## TECHNICAL BULLETIN

**TB NO. 1040**

**SUBJECT:**            **Revision of Main Bearing Cap on VEE Engines**

P-033-558-C

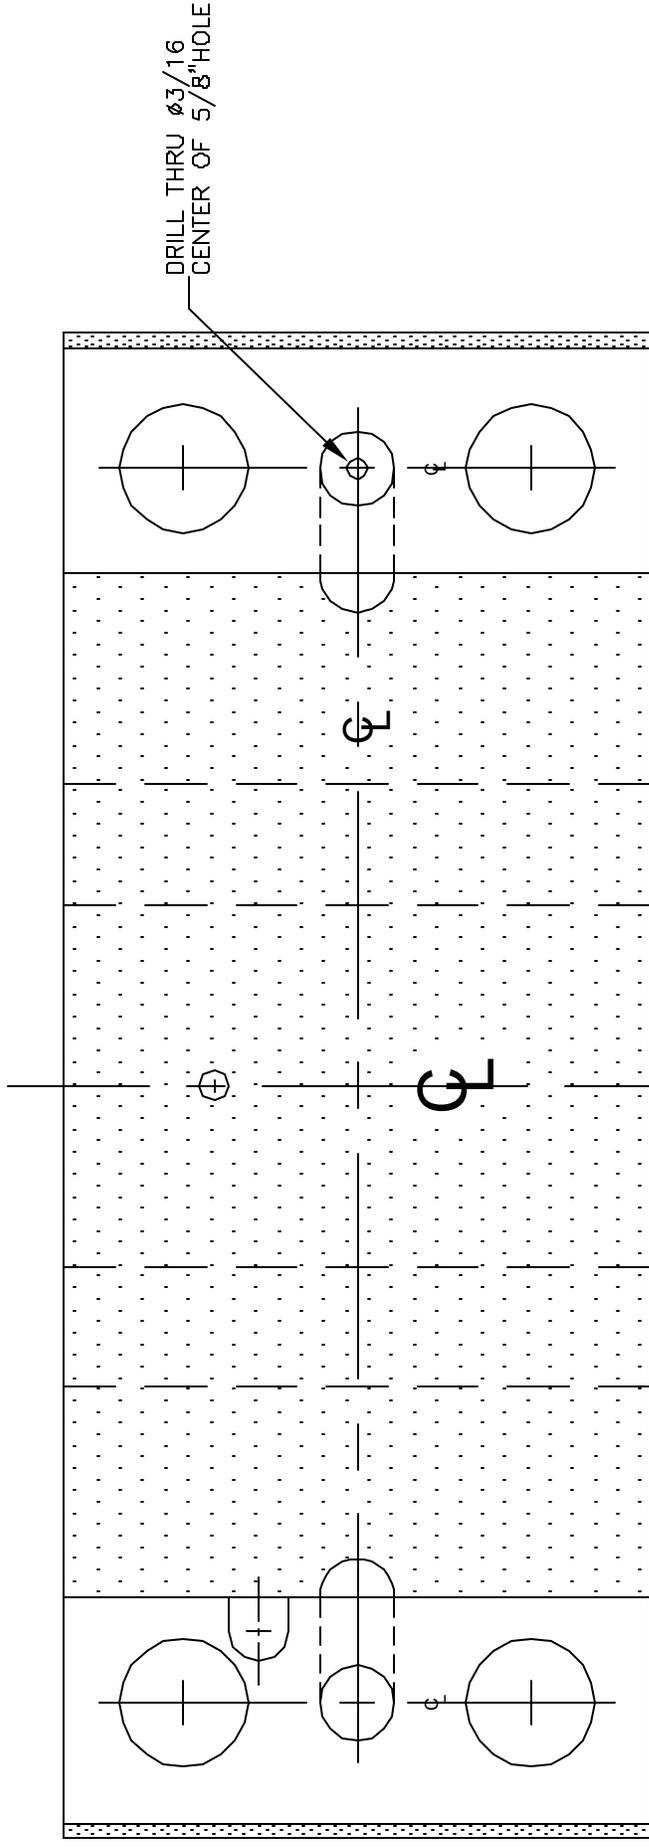
**PROBLEM:**            Some reconditioned bedplates and pre-1972 models do not have the center main cap drilled for oil circulation

**SOLUTION:**            Modify center main cap for oil vent

Please refer to EnDyn drawing **P-033-558-C** for the proper size and location of the vent hole.

- DRILL 3/16" VENT HOLE IN THE CENTER MAIN BEARING CAP AS SHOWN.
- VENT HOLE IS TO PROVIDE OIL CIRCULATION THROUGH THE MAIN BEARING TO IMPROVE COOLING & LUBRICATION AT THIS LOCATION. THIS IS NOT NECESSARY ON THE OTHER MAIN BEARING CAPS SINCE THESE BEARINGS HAVE A THROUGH FLOW IN FEEDING COOLING OIL TO THE PISTONS.
- STAMP TOP OF CAP "CENTER MAIN ONLY"
